12<sup>th</sup> December 2022

**Re: Parramatta Light Rail Stage 2 EIS**

Figure 7: Map showing the two Camellia to Rydalmere alignments (Source: TfNSW)

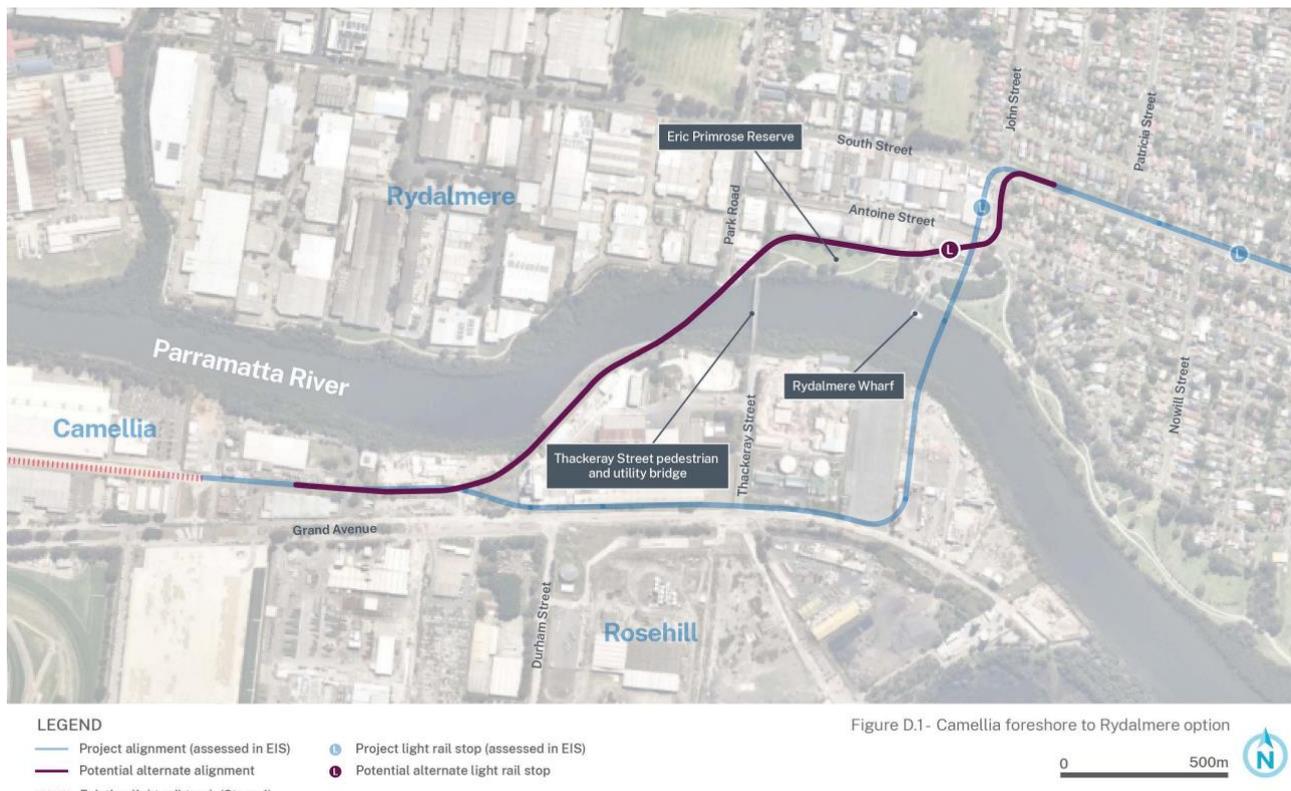
Appendix D of the EIS sets out an alternative route for connecting Rydalmere and Camellia, taking the light rail and the ATL along the foreshore of the Parramatta River (Figure 7). Our initial response is that the **Grand Avenue alignment is preferred**. The foreshore is a sensitive environment with established mangrove forests which would be permanently altered by transport infrastructure running very close to the river's edge. We understand that it will be difficult to acquire sufficient land along the foreshore to locate the light rail tracks well away from the water. However, we definitely support the addition of a standalone shared path along the foreshore. This would require a much narrower strip of land.
